COUNCIL ASSESSMENT REPORT

SYDNEY EASTERN CITY PLANNING PANEL

PANEL REFERENCE & DA NUMBER	PPSSEC331 – DA.2022.44.2
PROPOSAL	Modification to the approved Burwood Urban Park and Cultural Centre. Amendments include lowering of finished floor levels, internal reconfiguration, increased gross floor area, expanded theatre, relocation of studio from ground to lower ground, change of use from café to a food and drink premises with extended hours, amendments to design of 'marker' structure and modification to approved landscaping scheme
ADDRESS	<ul style="list-style-type: none"> • Part 2-4 Conder Street, Burwood – Burwood Library and Carpark • Part 52-60 Railway Parade, Burwood – Burwood Place • Part Railway Parade Road Reserve • Part Conder Street Road Reserve
APPLICANT	Mecone NSW Pty Ltd
OWNER	Burwood Council & Wynne Ave Property Pty Ltd
DA LODGEMENT DATE	25 July 2024
APPLICATION TYPE (DA, Concept DA, CROWN DA, INTEGRATED, DESIGNATED)	S4.55 (2) Modification Application

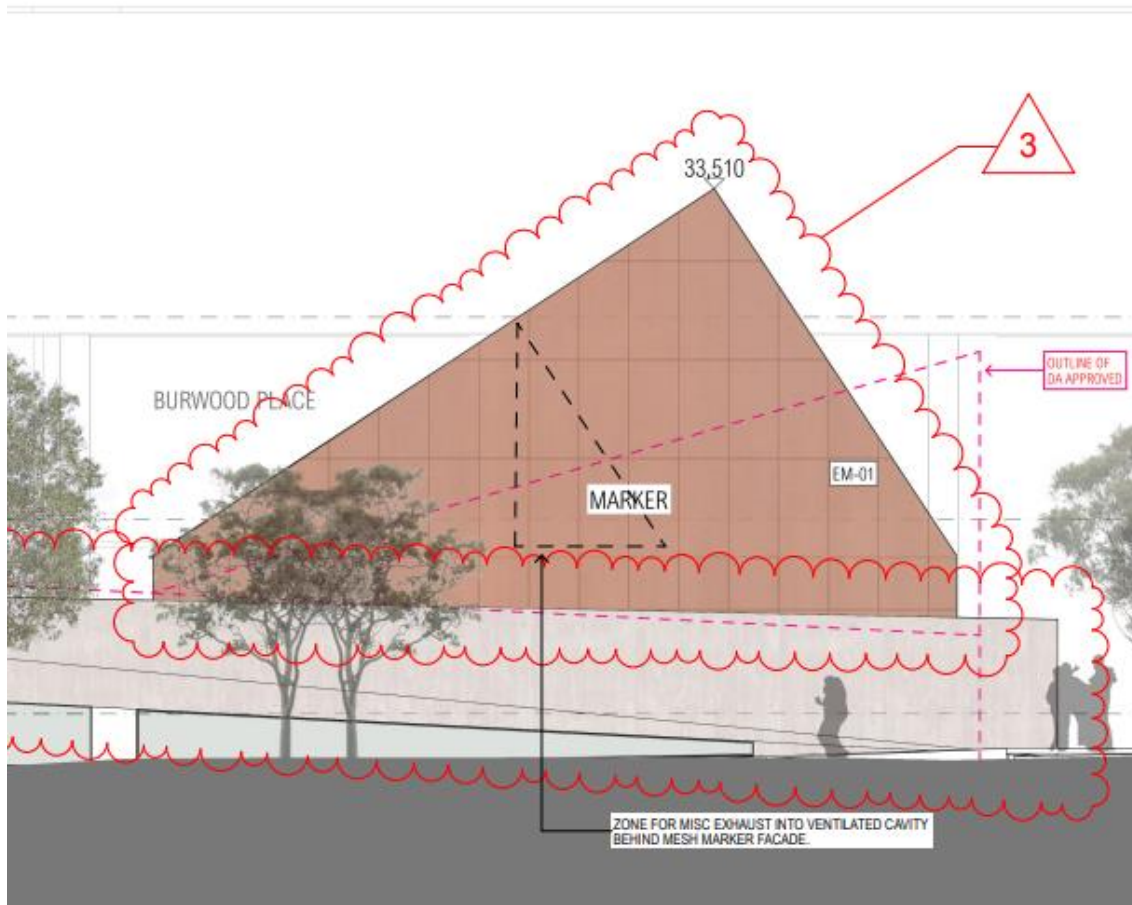
- Details of how box office sales will be conducted
- The mechanical ventilation shall be clearly indicated on the elevation plans to enable an assessment of its visual impacts.

Mechanical ventilation: The applicant has submitted additional elevation plans to show the location of the mechanical ventilation within the 'marker' structure. The exhaust and ventilated cavity will be located behind a mesh material on the western elevation of the 'marker' as shown below:
